ADDENDUM 01, DELTA 01

DATE 01.30.2026

PROJECT: Santa Rosa Freestanding Emergency Room

ARCHITECT'S PROJECT NUMBER:
225014.00

A150

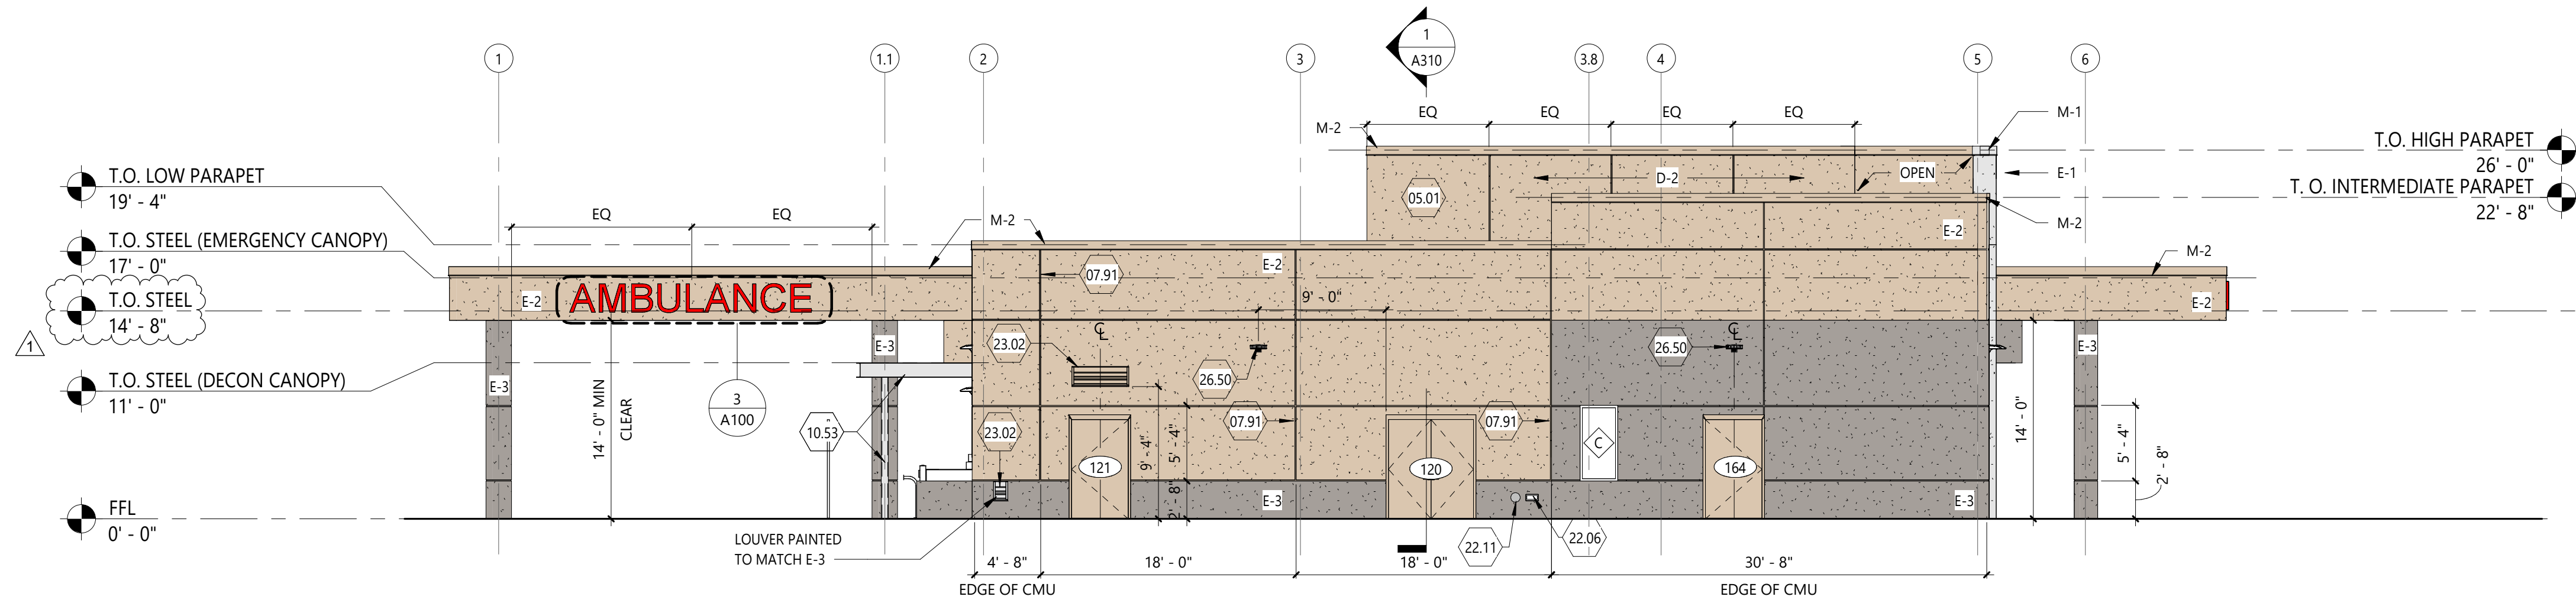
1. Reference Detail 1: "Reflected Ceiling Plan:"
 - a. Room tag added to indicate the location of the linen alcove per AHCA Stage II review comment.

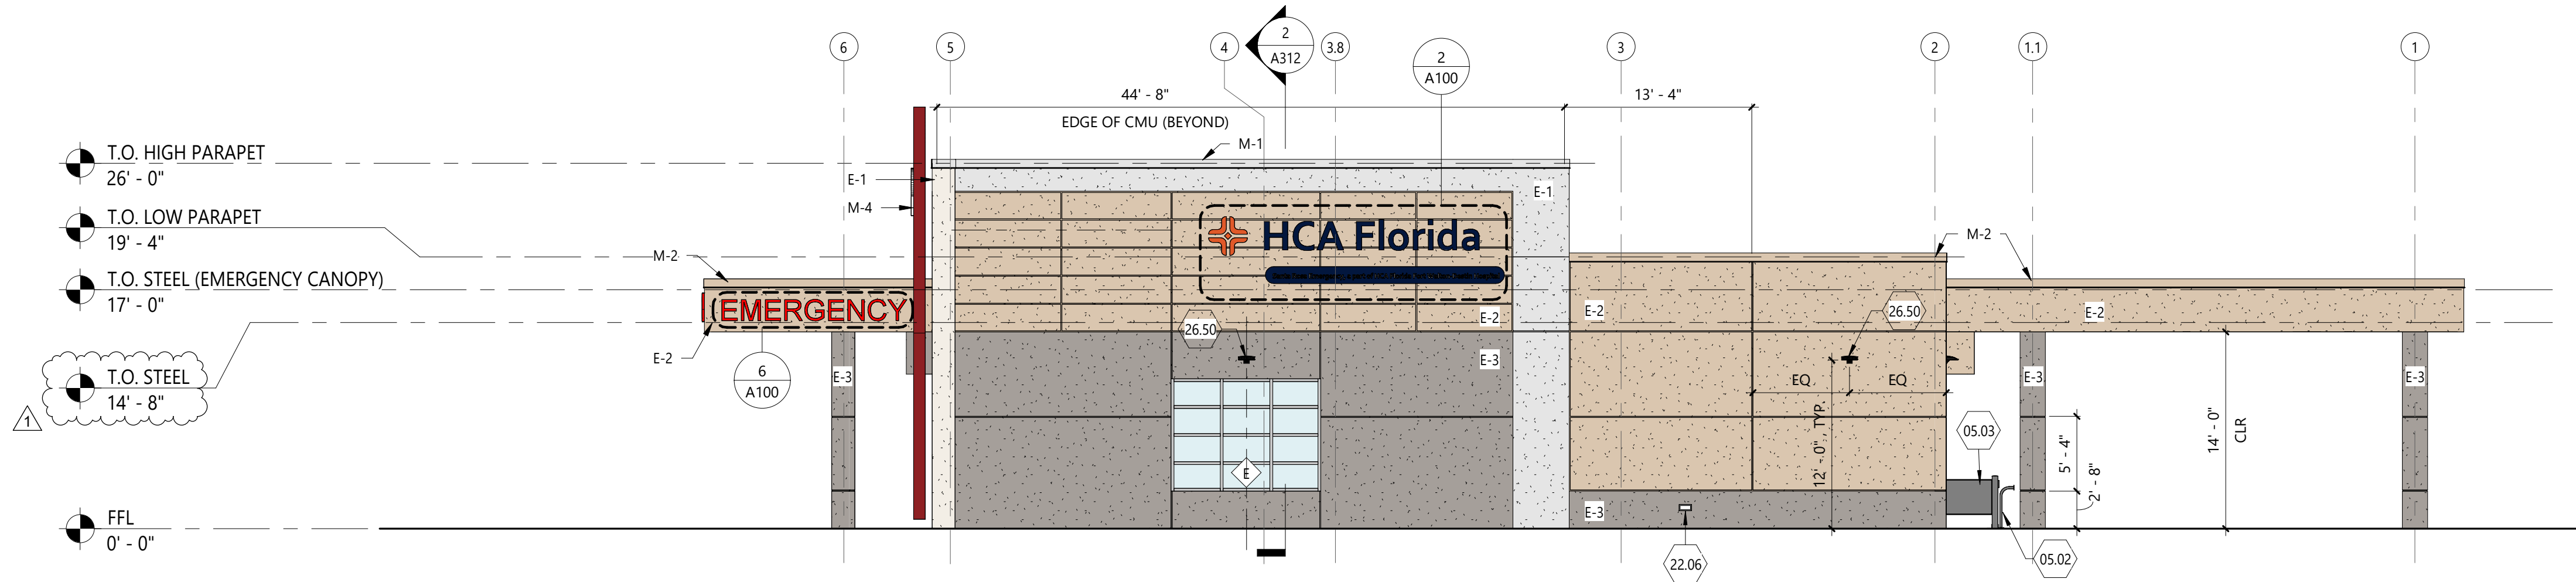
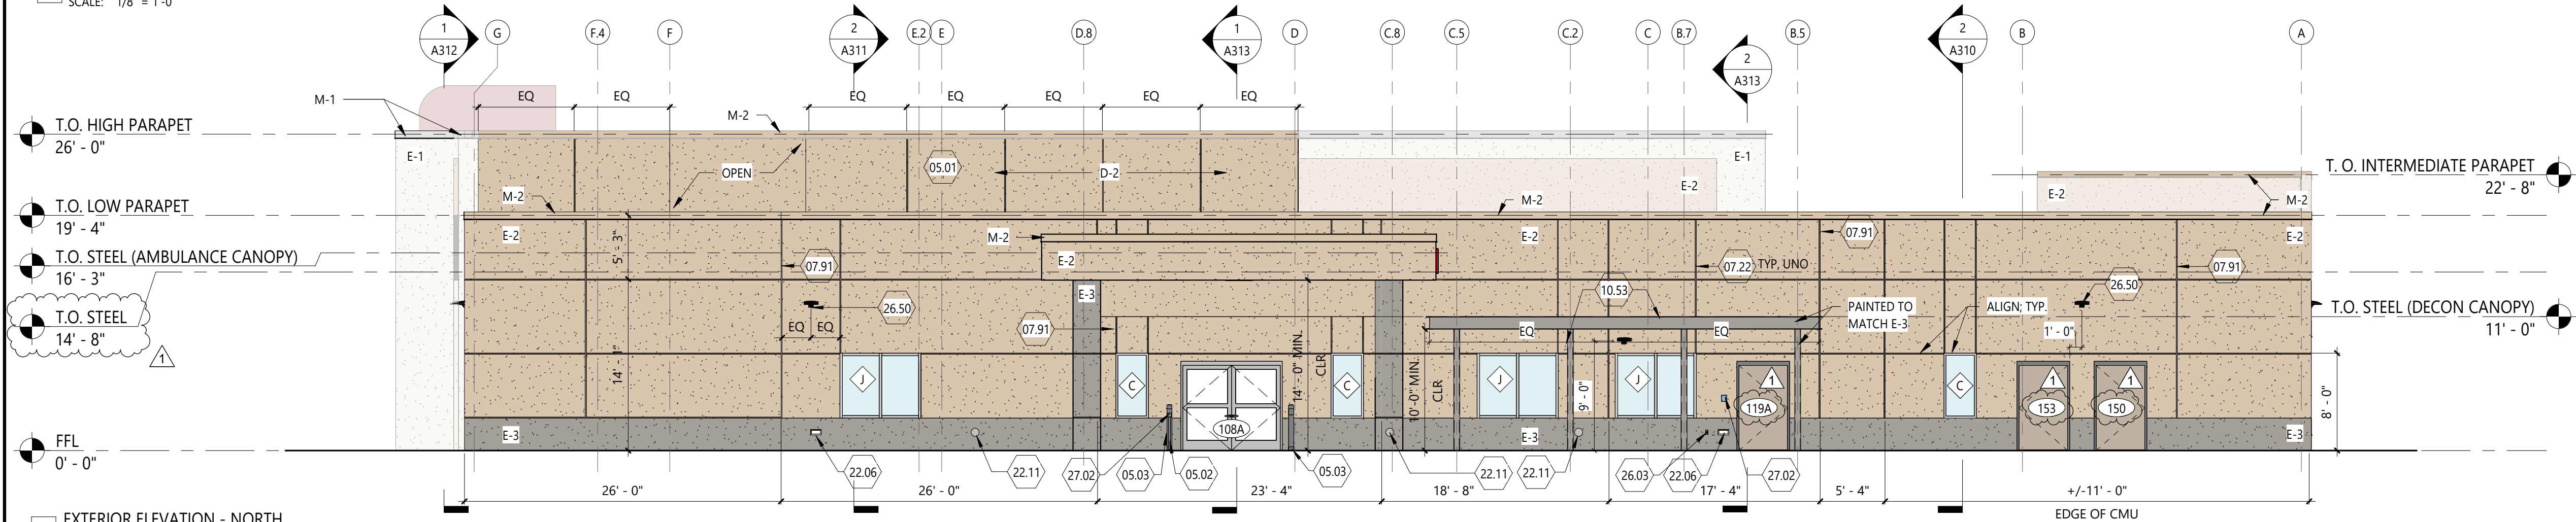
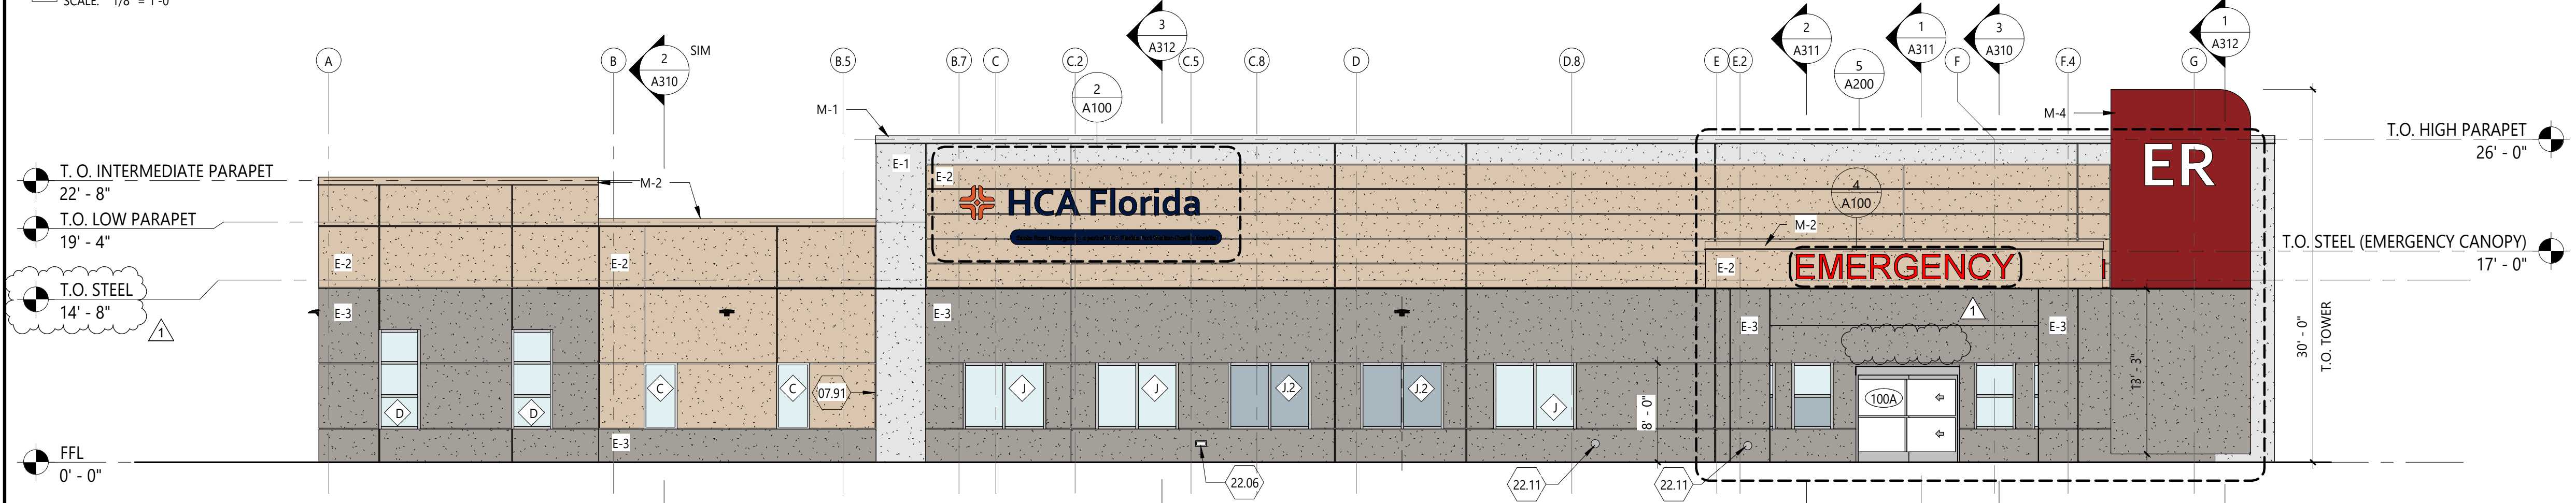
1. Reference Detail 1: "Exterior Elevation – South:"
 - a. Elevation tag added to indicate the top of steel elevation for additional clarification. Graphic change only, no scope of work change.
 - b. Removed the small "Emergency" sign above the sliding entrance doors.
2. Reference Detail 2: "Exterior Elevation – North:"
 - a. Elevation tag added to indicate the top of steel elevation for additional clarification. Graphic change only, no scope of work change.
 - b. Door tag added at Door 119A for additional clarification. Graphic change only, no scope of work change.
 - c. Door tag added at Door 150 for additional clarification. Graphic change only, no scope of work change.
 - d. Door tag added at Door 153 for additional clarification. Graphic change only, no scope of work change.
3. Reference Detail 3: "Exterior Elevation – East:"

- a. Elevation tag added to indicate the top of steel elevation for additional clarification. Graphic change only, no scope of work change.
4. Reference Detail 4: "Exterior Elevation – West:"
 - a. Elevation tag added to indicate the top of steel elevation for additional clarification. Graphic change only, no scope of work change.

1 EXAM 9 (INDIVIDUAL OF SIZE) - 137 - ENLARGED PLAN
SCALE: 1/2" = 1'-0"

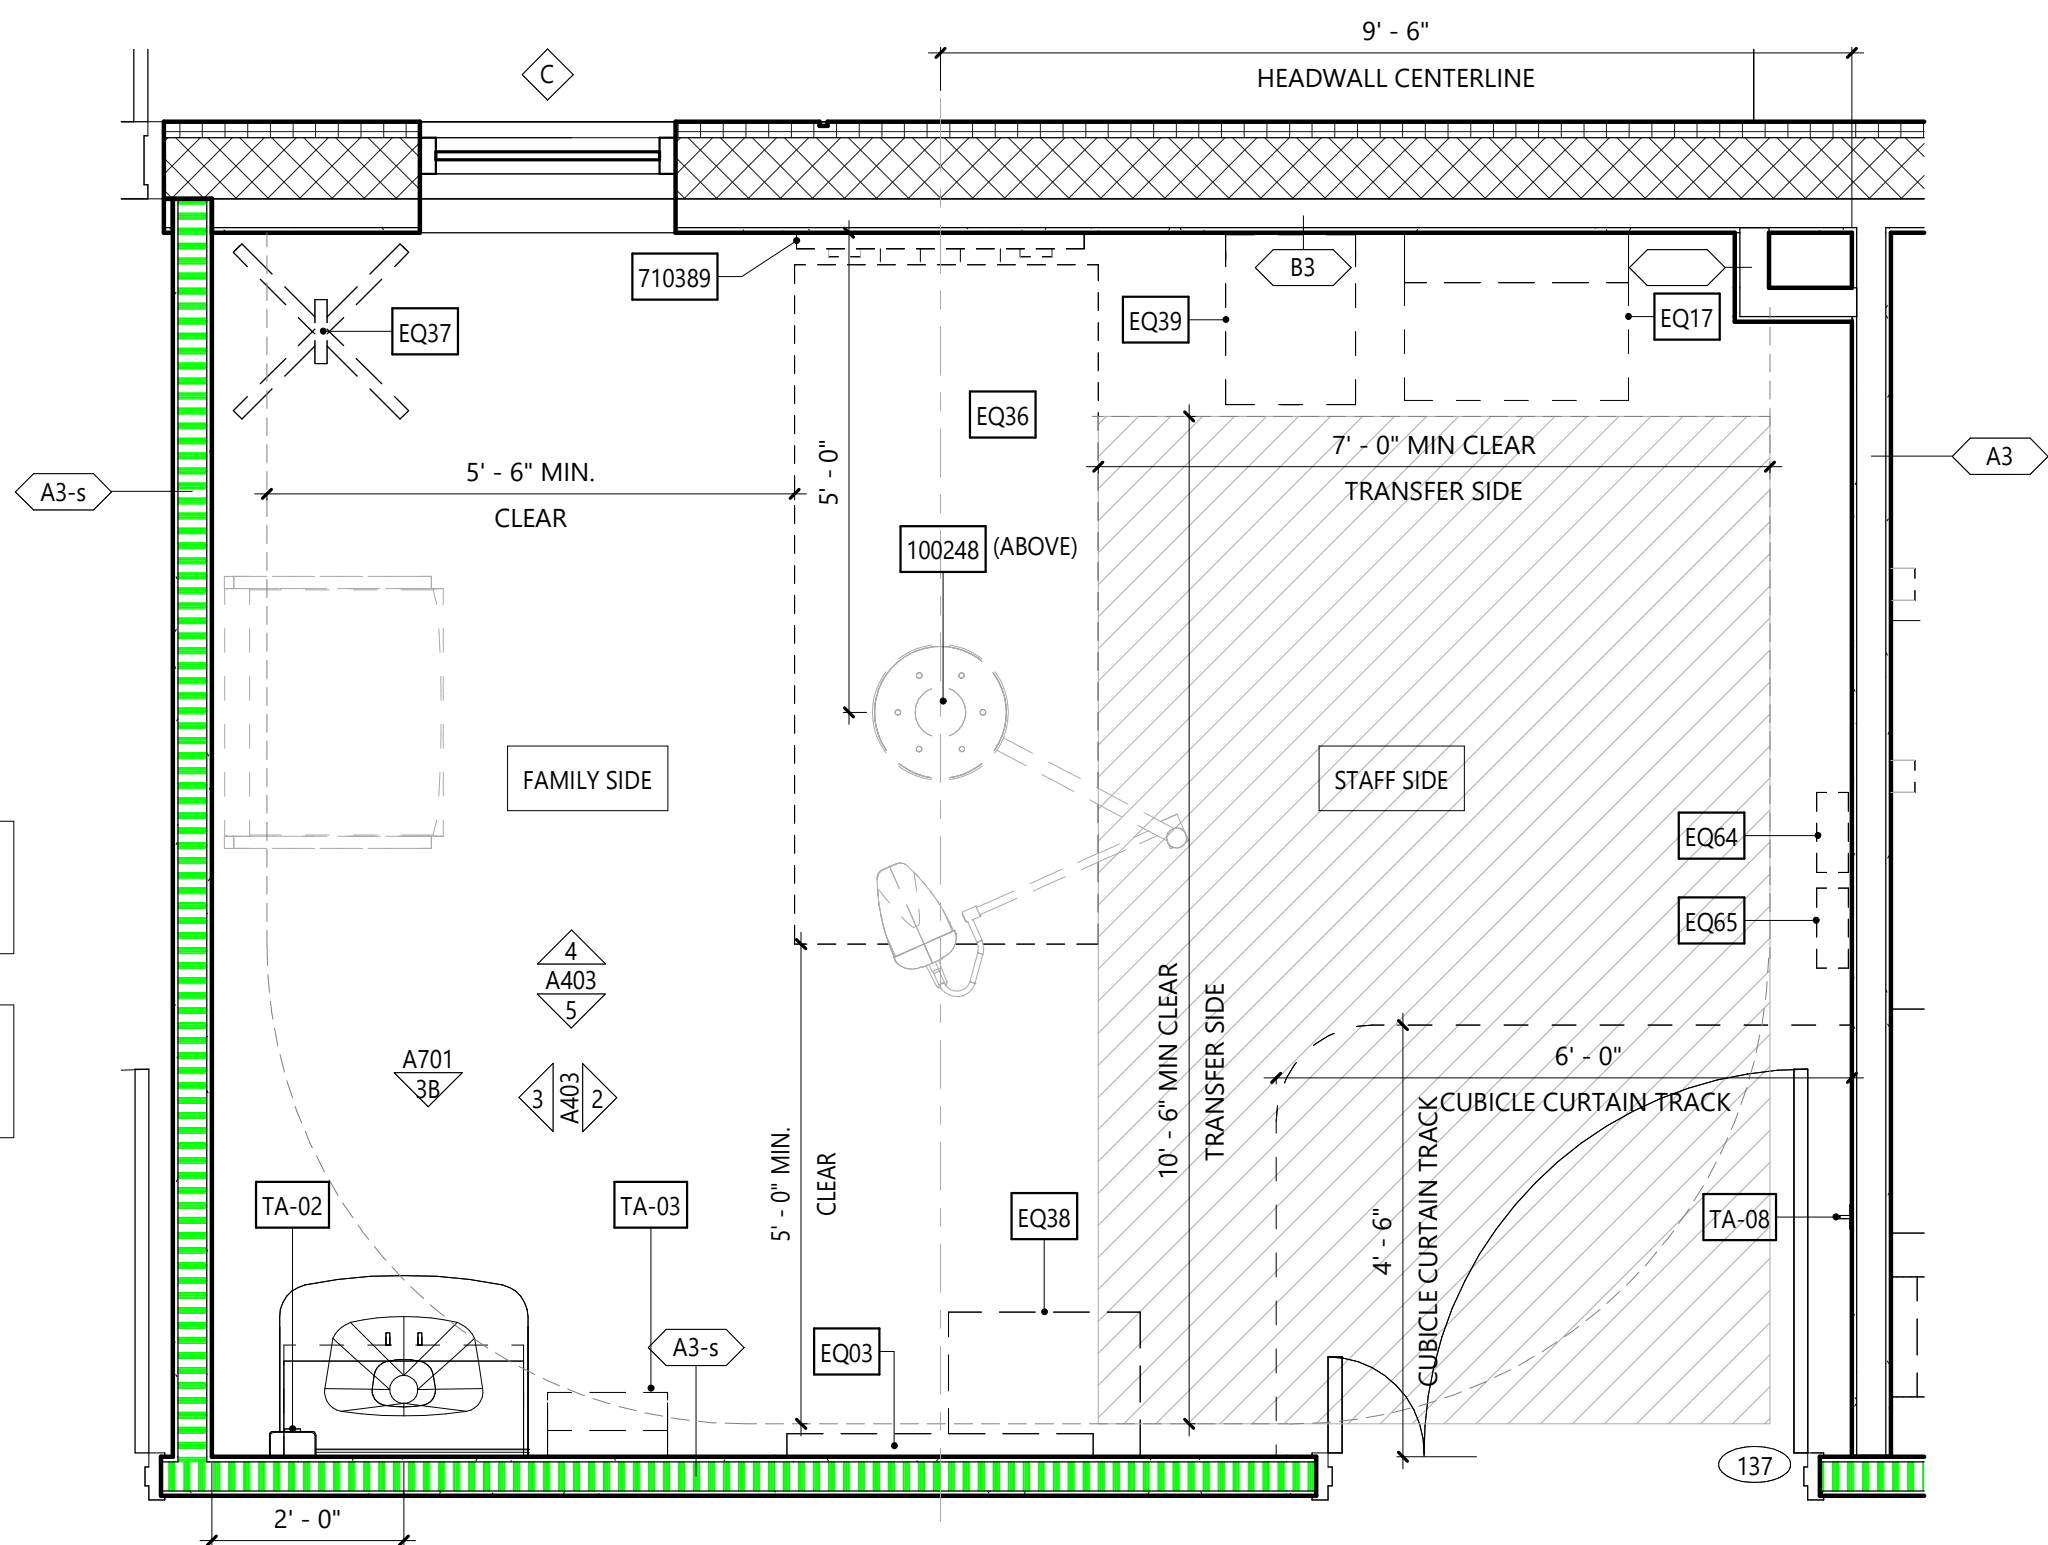
1. Reference Detail 1: "Exam 9 (Individual of Size) – 137 – Enlarged Plan:"
 - a. Note added to indicate the gross and net room areas of the enlarged pelvic exam per AHCA Stage II review comment. Graphic change only, no scope change.
